# JOURNAL OF COASTAL AND HYDRAULIC STRUCTURES

## Physical modelling of tsunami barrier and debris interaction

Schlesier et al.

Subject: [JCHS] Editor Decision

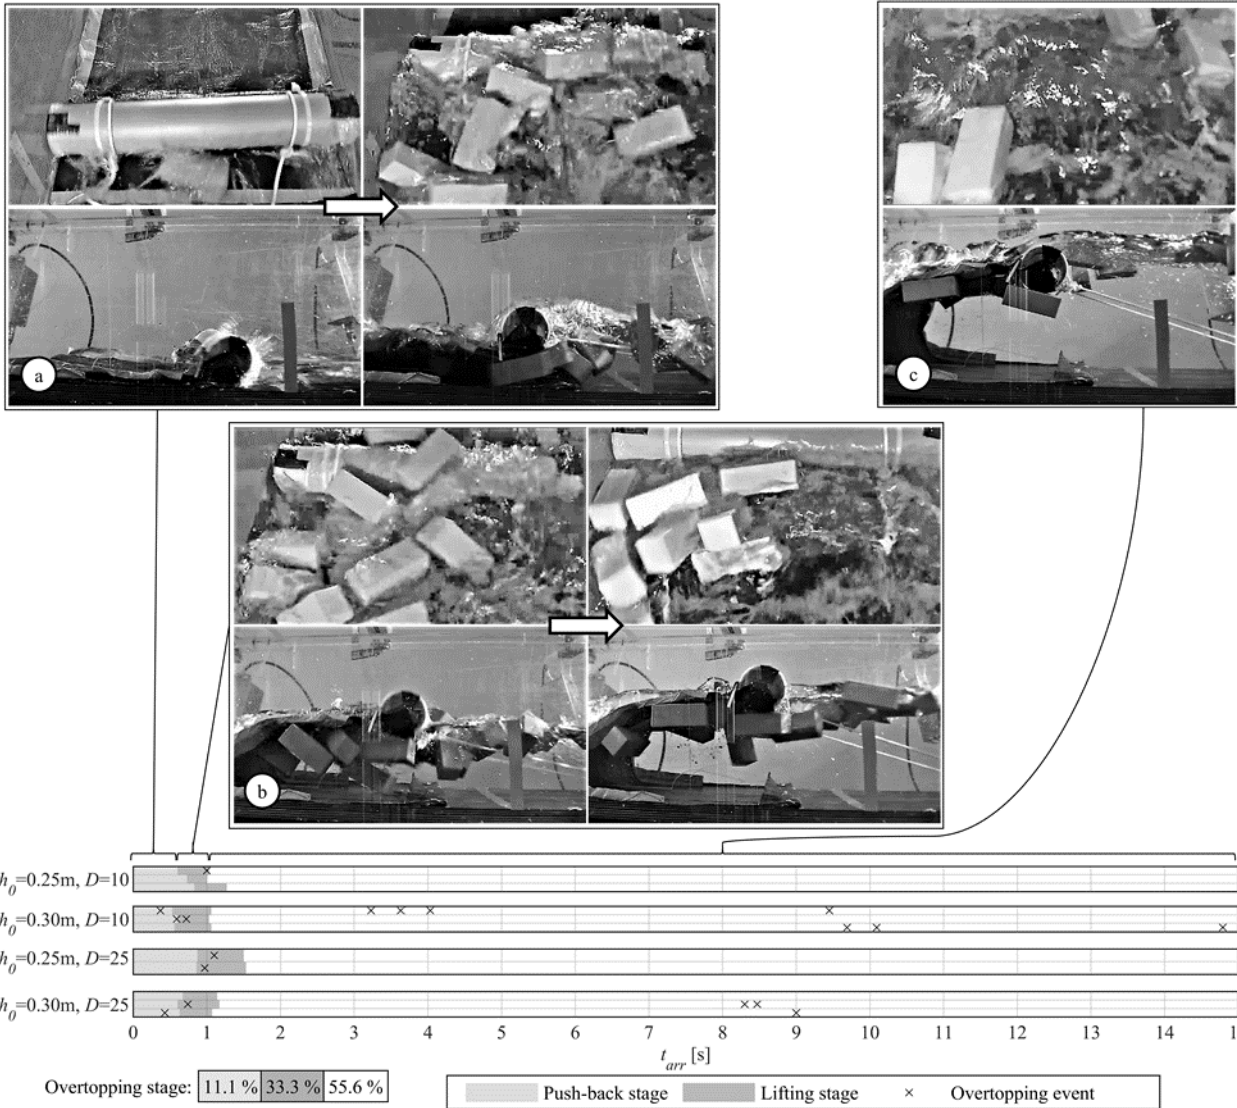
*Section 4: Were there any 3D effects from the debris? Just based on Figure 7, it seems that the debris skewed slightly to one side which could incur some 3D influences. Was that the case for all tests or just the one?*

We thank the reviewer for this interesting question. We checked the CAM 2 video data for all twelve runs with debris and concluded that the skewed debris positions depicted in Figure 7 was random. Nevertheless, we decided to replace the camera image shown in Figure 7 for a more representative one.
